Insertion loss budget for 40/100GBASE-CR4/10

Adam Healey
LSI Corporation

IEEE P802.3ba Task Force Meeting
San Francisco, CA
July 2009

Loss budget – Draft 2.1

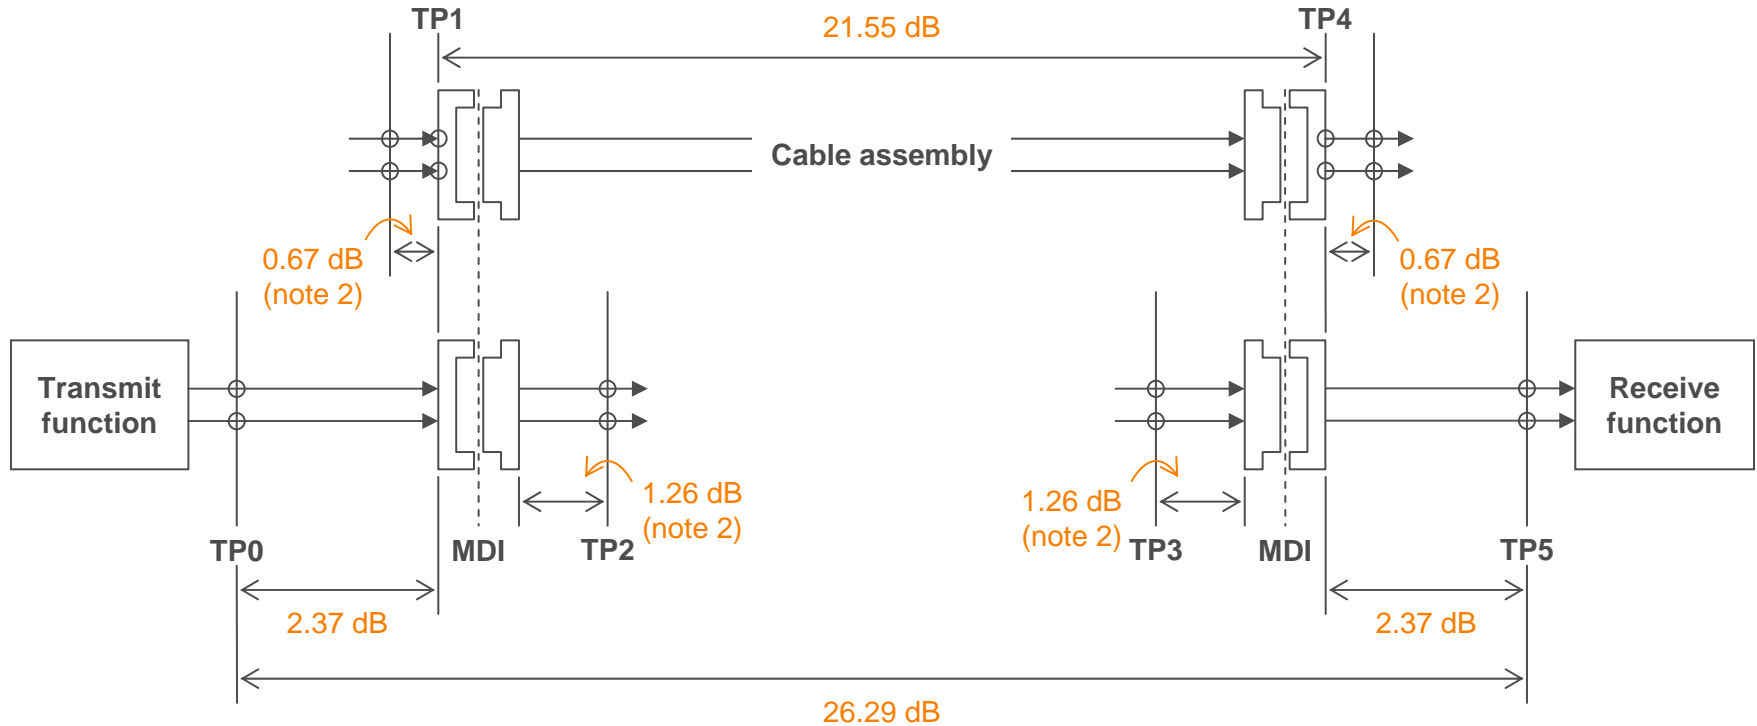
NOTE 2 – Intended values; equations in Draft 2.1 are in error

- Compare the loss budget from TP0 to TP5 to the 10GBASE-KR 23.36 dB budget (based on value of A_{max} at 5.15625 GHz)

Illustration of recommendations

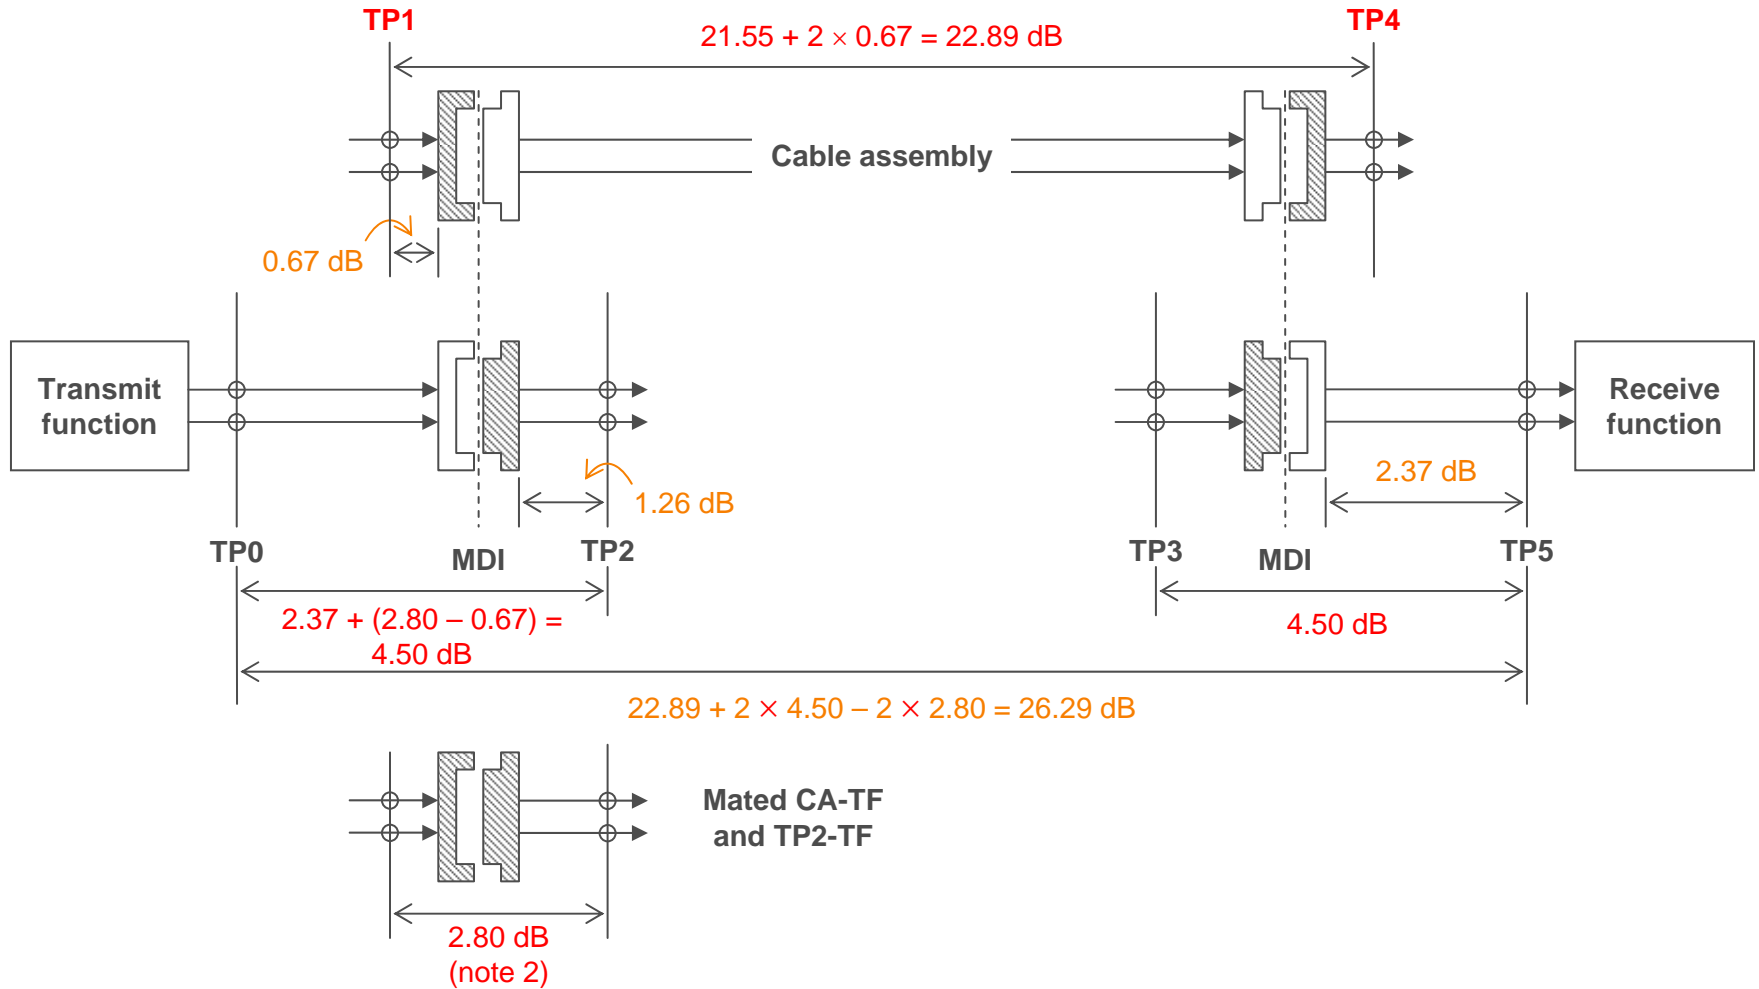
Clarification of test points and fixtures – Comment #114

- Propose to move TP1 and TP4; increase the allowance for cable assembly plus test fixtures accordingly
- Propose to define recommended host channel insertion loss from TP0 to TP2 (and TP3 to TP5)
 - Similar to 86A.6
- Propose to specify normative mated TP2-TF and CA-TF characteristics
 - Similar to 86A.6

Draft 2.1 – Line fit, 50 MHz to 6 GHz

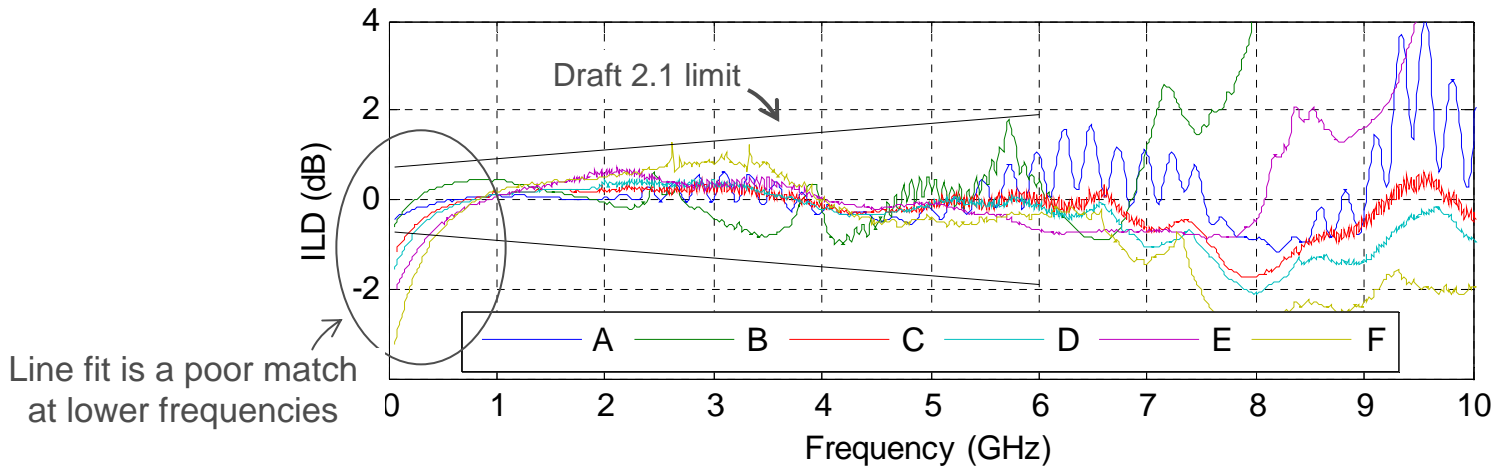
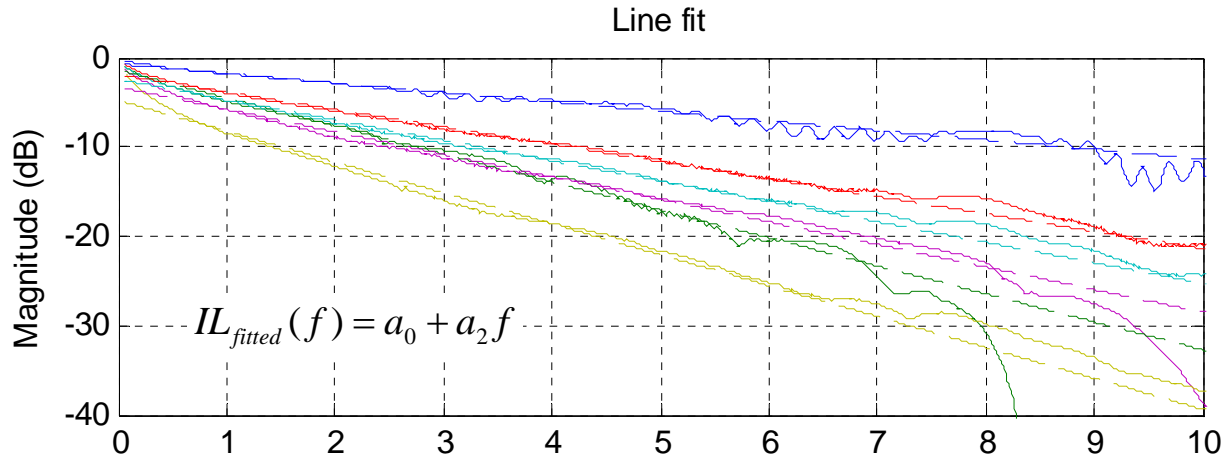
Comments #139, #292 – Fitted insertion loss

- The fitted insertion loss, IL_{fitted} , is defined to be a least mean squares fit of the measured insertion loss, IL , to a linear function of frequency
 - This fit is calculated over a frequency range spanning 50 MHz to 6 GHz
- The line fit method is also employed by 10GBASE-KR but that fit is calculated over a frequency range spanning 1 GHz to 6 GHz, where dielectric loss is expected to dominate
- The characteristics of the cable assembly (and channel) are better controlled by expanding the frequency range of the fit but the fitting function must consider “skin effect” losses that are evident at lower frequencies, especially in cable assemblies
- A polynomial in the square root of f is a good model for the cable assembly (and channel) insertion loss

Proposal – Polynomial fit, 50 MHz to 7.5 GHz

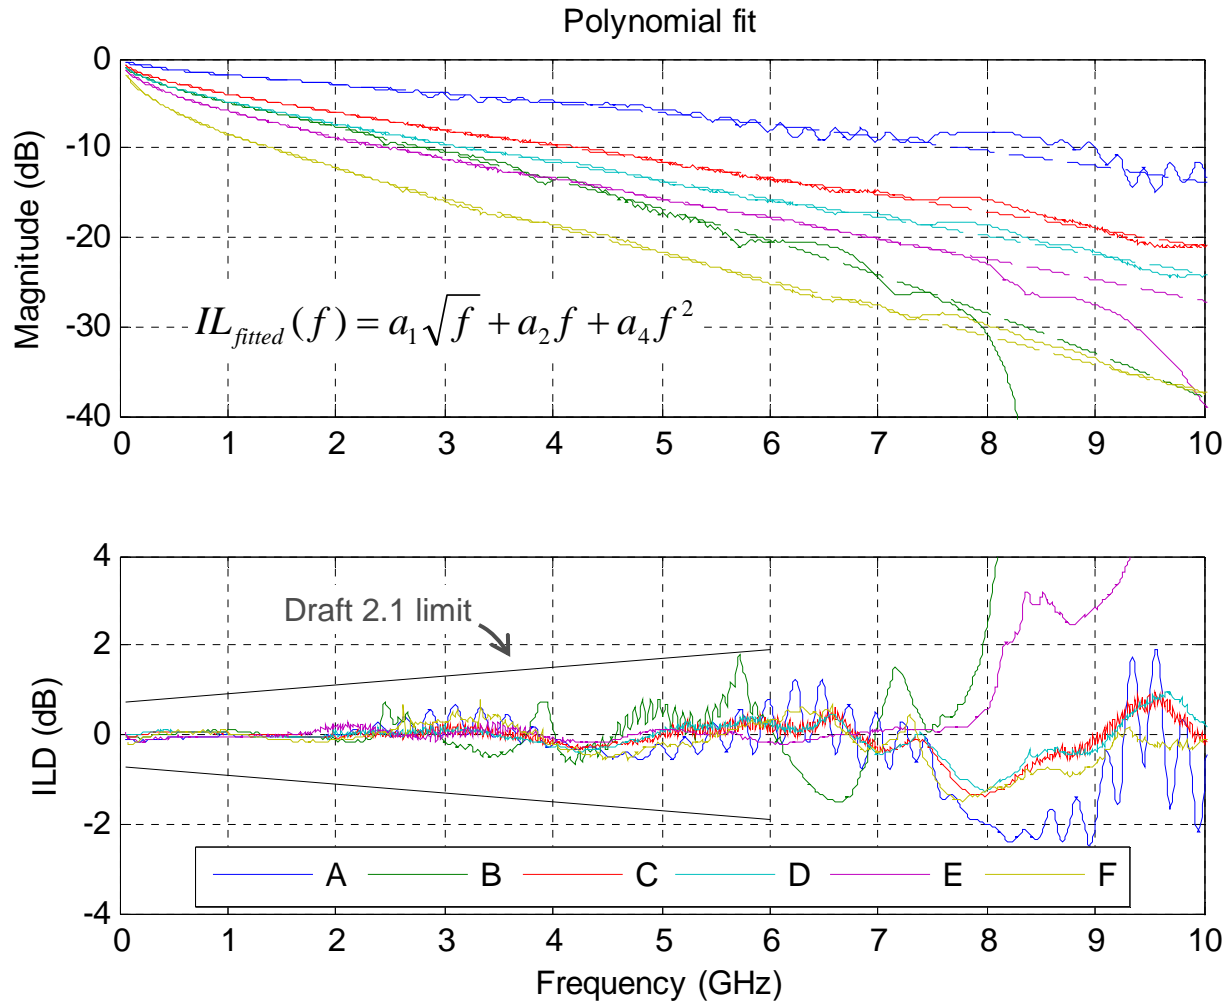
Polynomial fit is a good match across a broad range of frequencies

- Replace the line fit method described in 85.10.3 with a polynomial fit
- Constrain the coefficients of the polynomial fit and the insertion loss deviation rather than the insertion loss function itself
 - Delete 85.10.2
 - Bound coefficients of the polynomial fit in accordance with the agreed loss budget
 - Revisit insertion loss deviation requirements in light of the improved fit performance
- Replace test channel requirements of 85.8.4.2 with requirements based on a polynomial fit and associated insertion loss deviation

Loss budget – 7 m, 6.26 dB host insertion loss

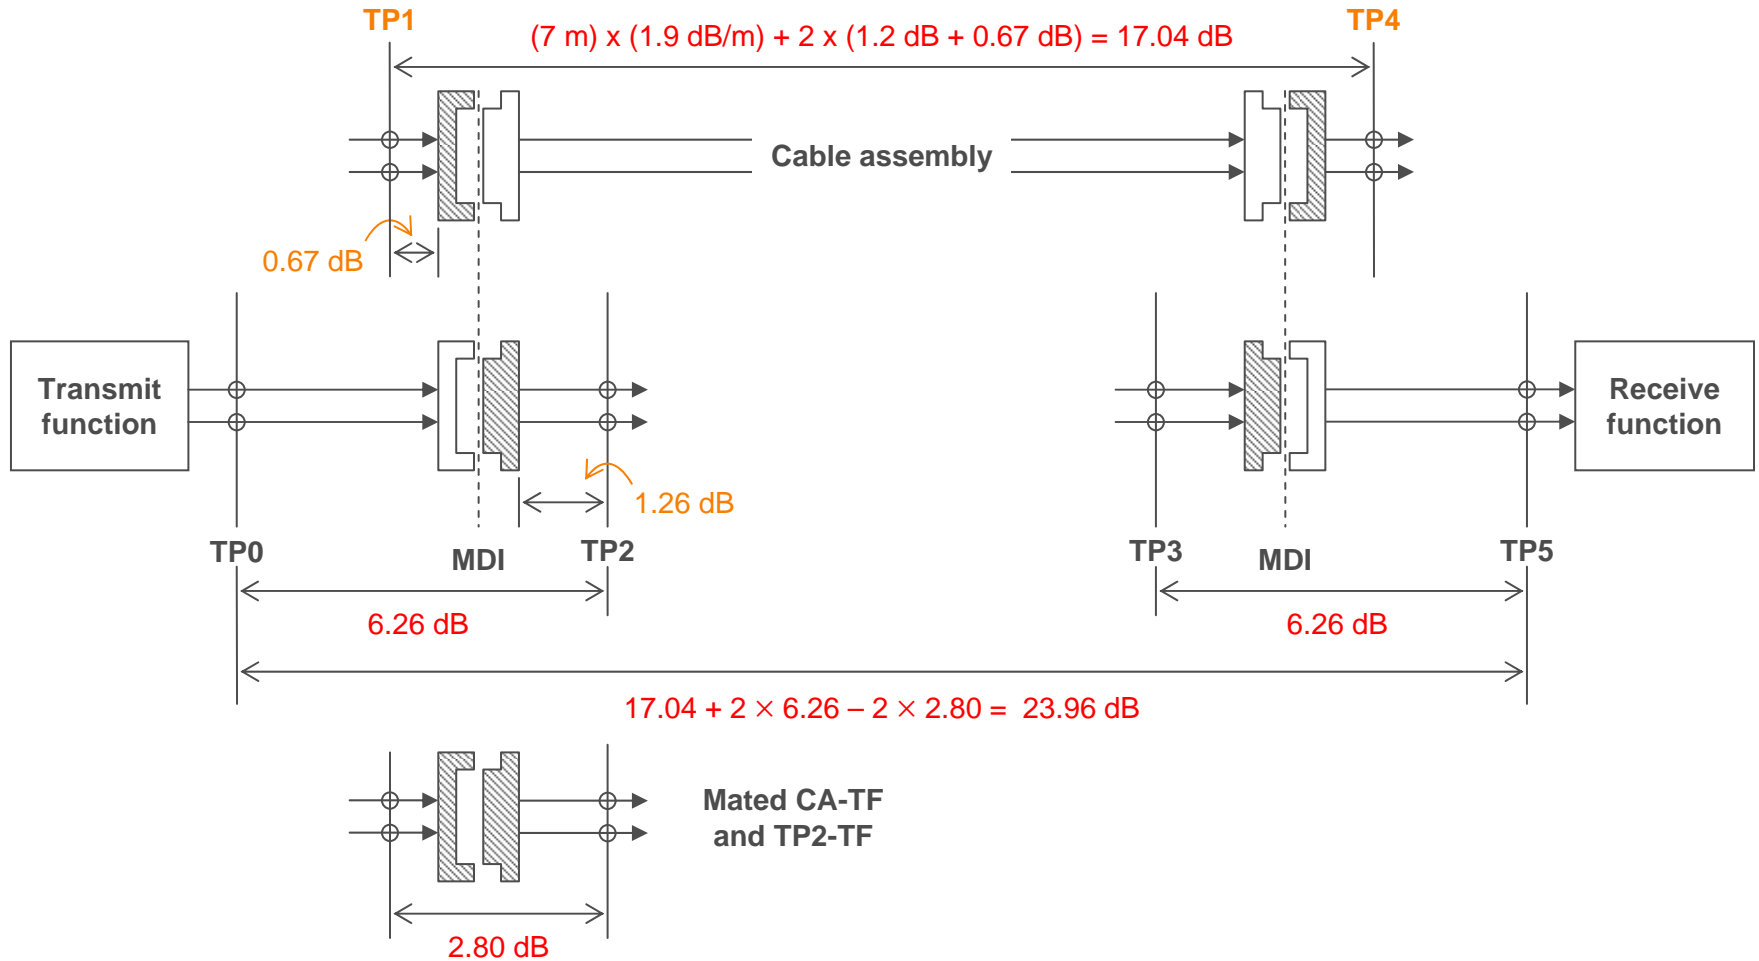
Host insertion loss allowance – Comments #96, #165

- Comment #96 suggests that the host printed circuit board (PCB) and connector insertion loss allowance be increased
 - 5.0 dB at 5.15625 GHz for the PCB trace, connector, and other impairments
 - 3.5 dB for the PCB trace only
 - This implies that the TP0 to TP2 (and TP3 to TP5) insertion loss allowance is 6.26 dB
 - To maintain a consistent loss budget. the commenter recommends that the cable assembly reach objective be reduced to 7 m
- Comment #165 suggests that the allowance for the host PCB trace alone be increased to 5.0 dB
 - Assume that this translates to a TP0 to TP2 (and TP3 to TP5) insertion loss allowance of 7.76 dB

Loss budget investigation – Pulse responses

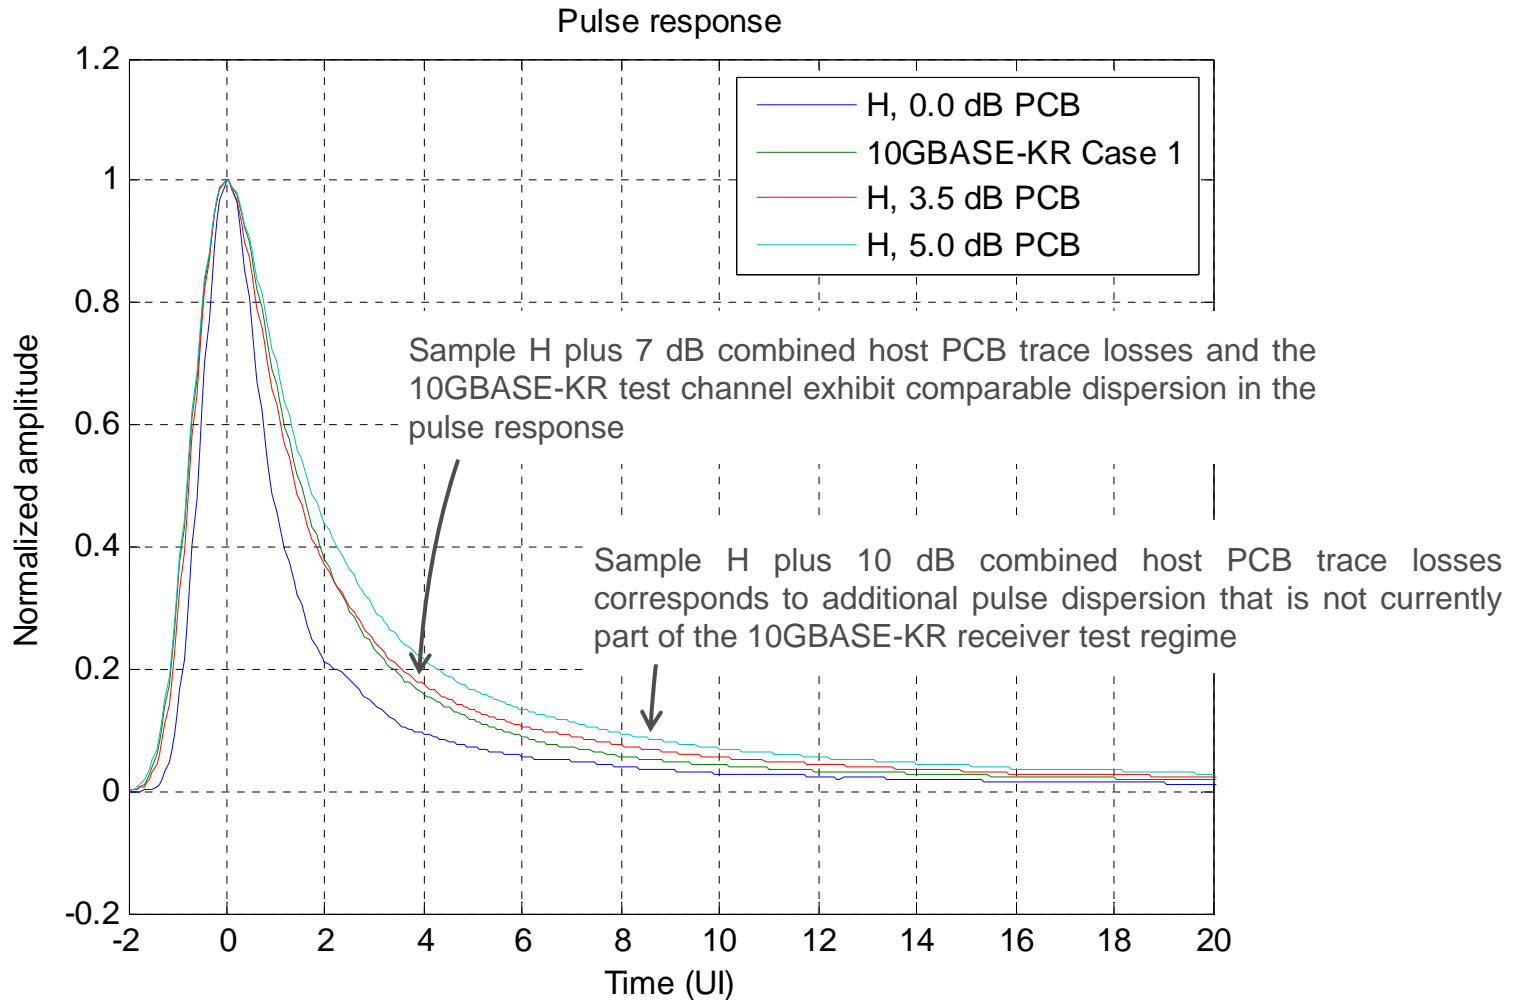
- 10GBASE-KR compliant solutions may be expected to support a 7 m cable assembly with host transmitter and receiver printed circuit board traces each exhibiting an insertion loss of 3.5 dB at 5.15625 GHz
- The insertion loss for a channel that includes 5.0 dB of printed circuit board trace loss at both the transmitter and receiver exceeds what is currently required for 10GBASE-KR receiver testing
 - Existing solutions may support this operating point but no general statements may be made based on the 10GBASE-KR specifications alone
- Note that comment #38 suggests that the mean time to false packet acceptance (MTTFPA) analysis for 40/100GBASE-CR4/10 may not be valid
 - It employs 10GBASE-KR error propagation statistics while 40/100GBASE-CR4/10 links exhibit more dispersion
 - Presumably, working within the 10GBASE-KR loss budget would alleviate this concern
